American Telecommunications Certification Body Inc.
6731 Whittier Ave, McLean, VA 22101

RE: CANHOLD INTERNATIONAL LIMITED

FCC ID: RRSBTHF009

After a review of the submitted information, I have a few comments on the above referenced Application.

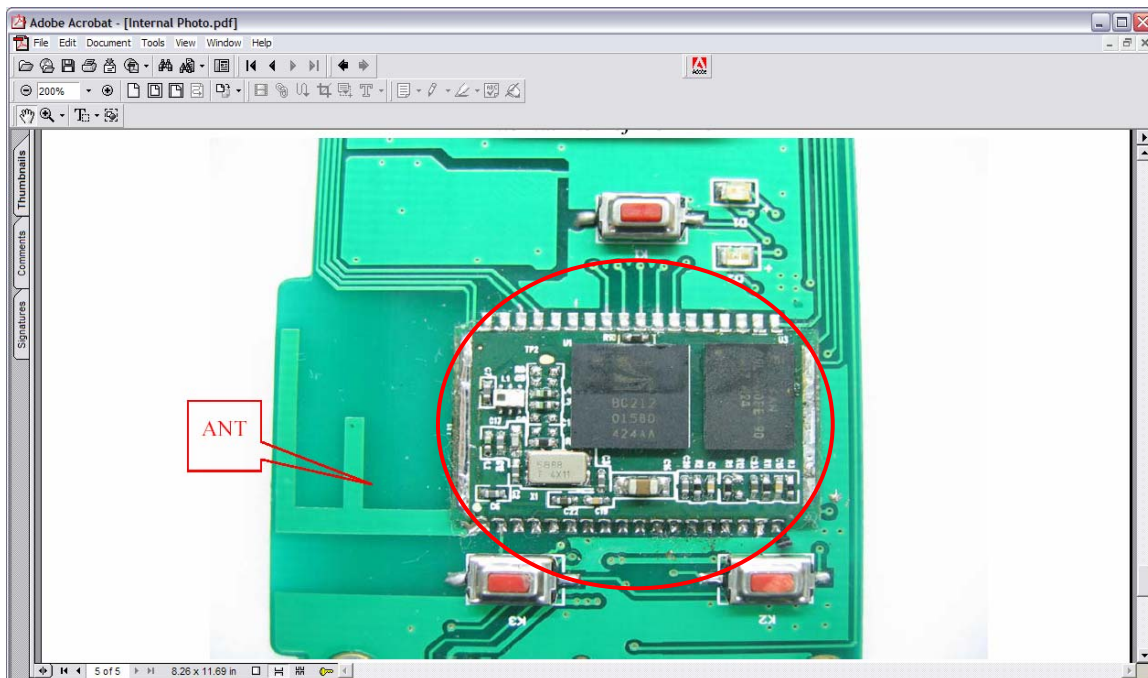
- 1) Please provide bottom view of the RF module/board shown:
